Kansas Department of Agriculture
 Division of Water Resources
CHANGE: P/U WORKSHEET & WATER USE CORRESPONDENT CHANGE

RE: Water Right,
File Nos. 18,144; 22,737-D1 & 22,737-D2

APPROVAL OF APPLICATION FOR CHANGE IN PLACE OF USE WATER RIGHT, FILE NO. 22,737-D2

Place of Use Change
File No(s) 18144, 22737 D1 & 22737 D2
T26 R31 Finney Co.

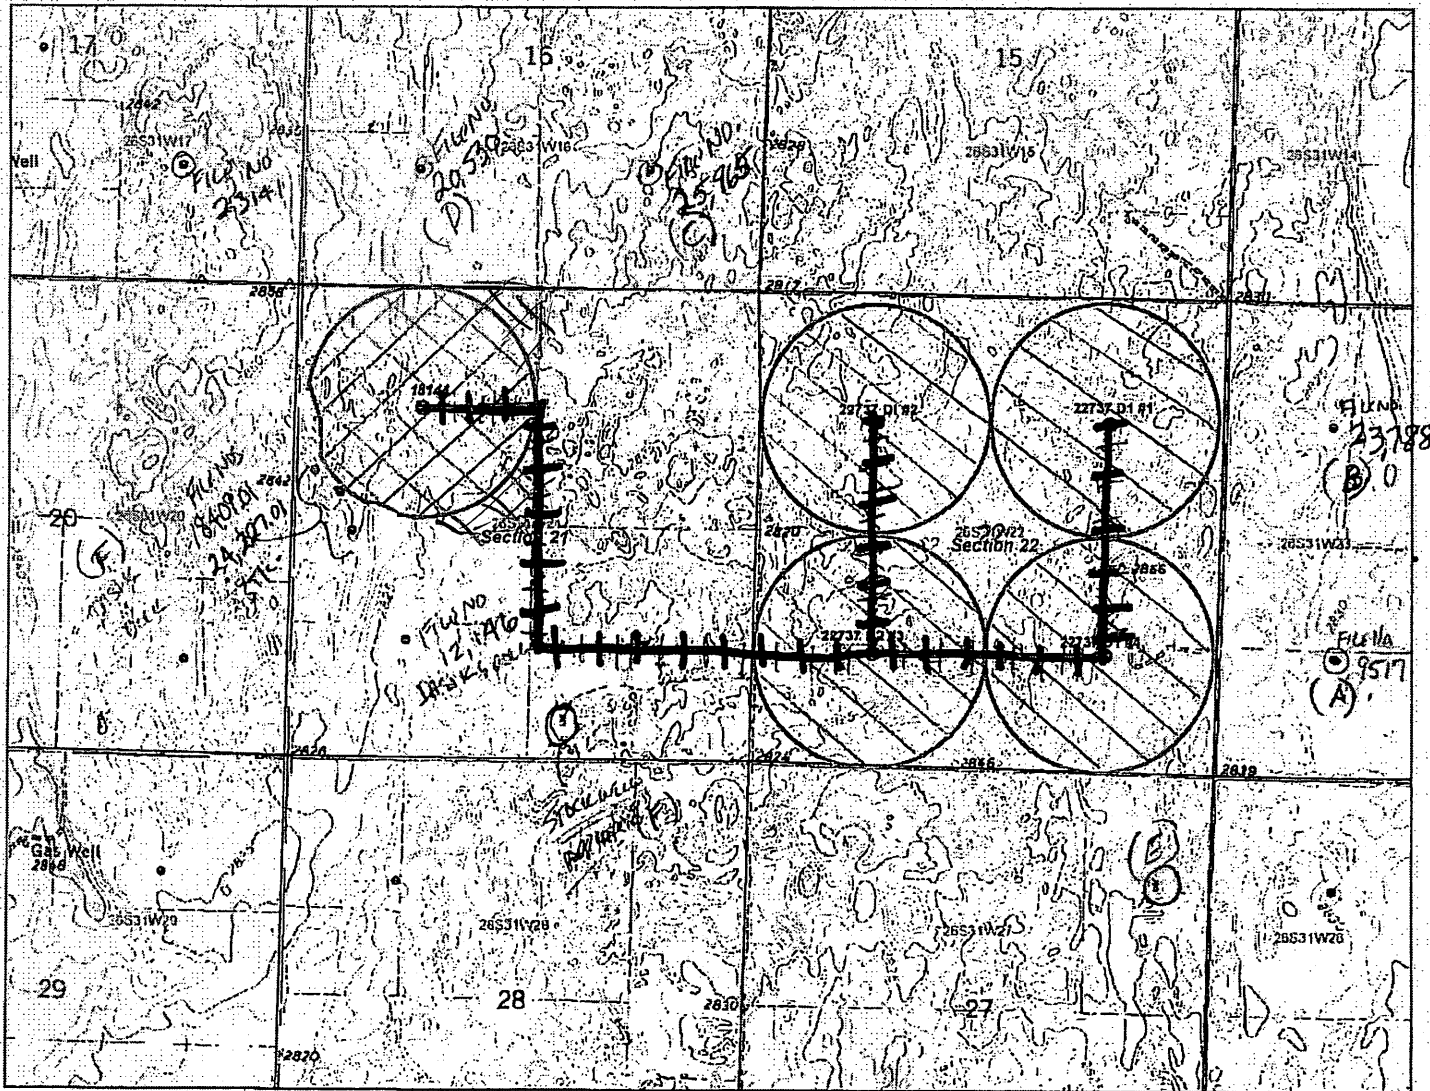
I'm working your applications. Please find attached the map from the proposed changes. Could you please show on the map any pipelines between the points of diversion. I've add a symbol for "pipeline" to the legend. It is a requirement per K.A.R. 5-5-2a, *Complete change application*. Easements for the pipeline would not appear to be needed as all of the property in the area where the pipeline may go is owned by either you or Irsik & Doll. If I need to contact Irsik & Doll please let me know.

Thank you. The map is what was needed for the applications per the regulation. I think you agree the list of the nearby well owners represents the folks to notify. I've completed that part of the process.

Place of Use Change
File No(s). 18144, 22737 D1 & 22737 D2
T26 R31 Finney Co.

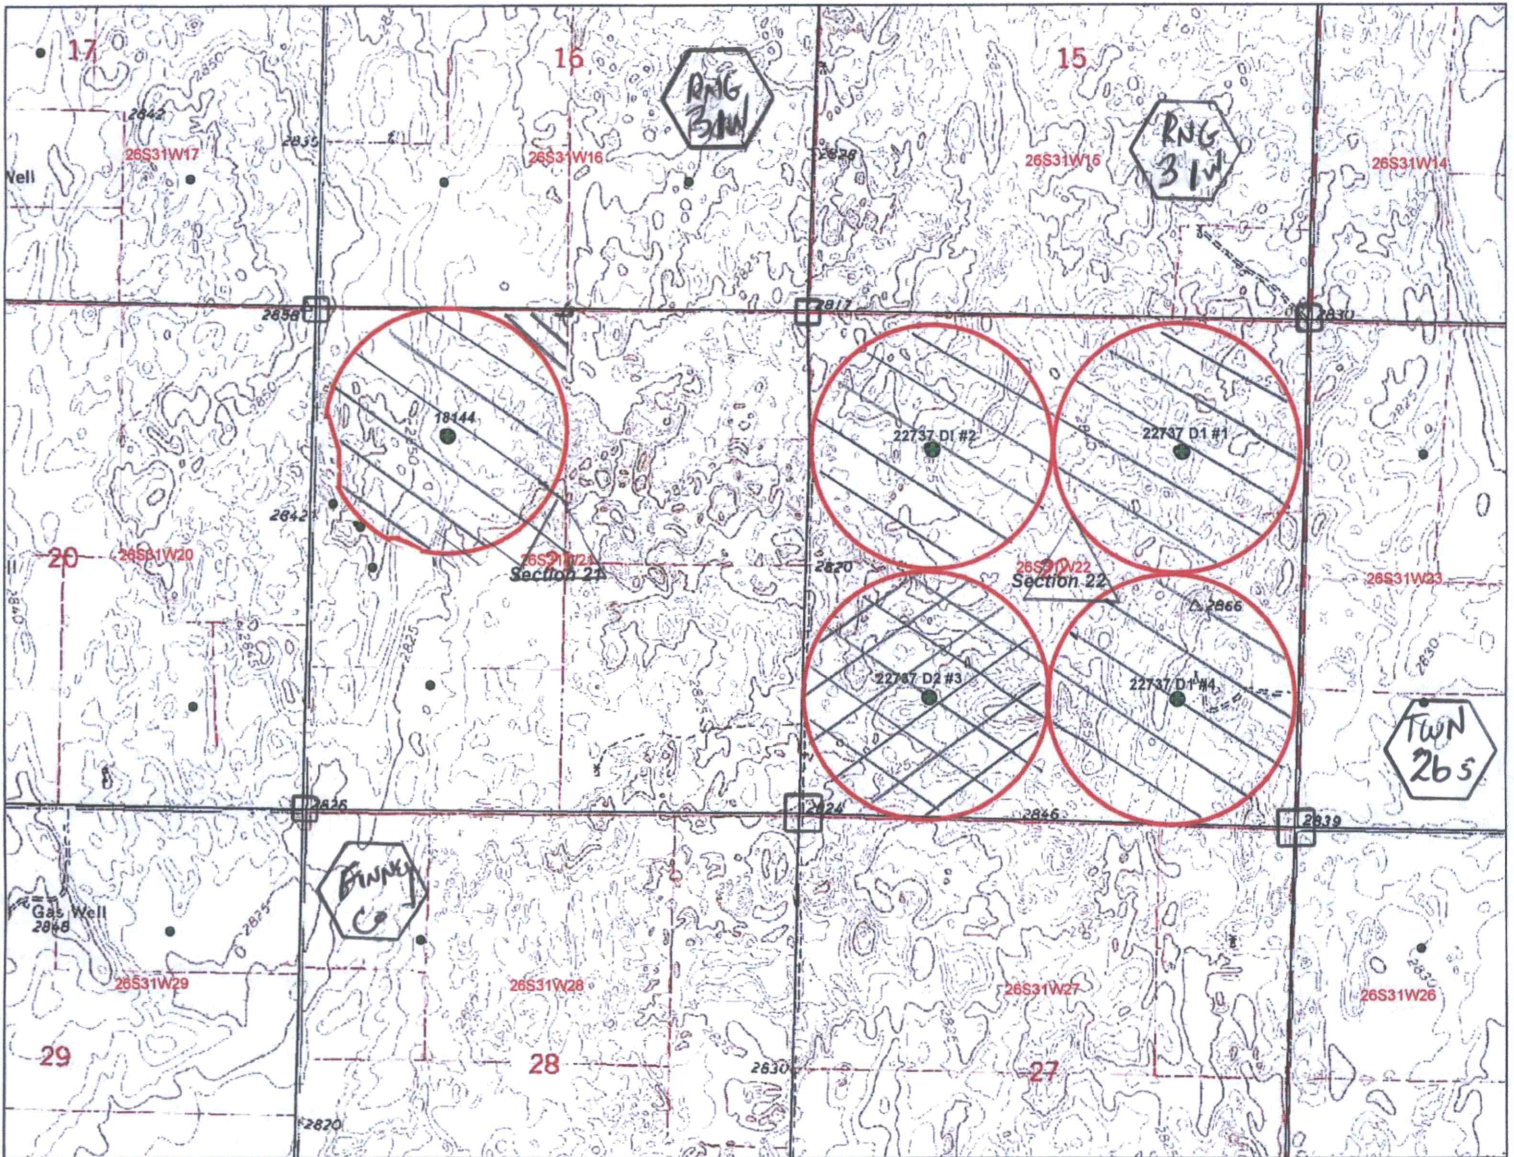
Map was also provided showing the proposed pipeline to connect all the land.
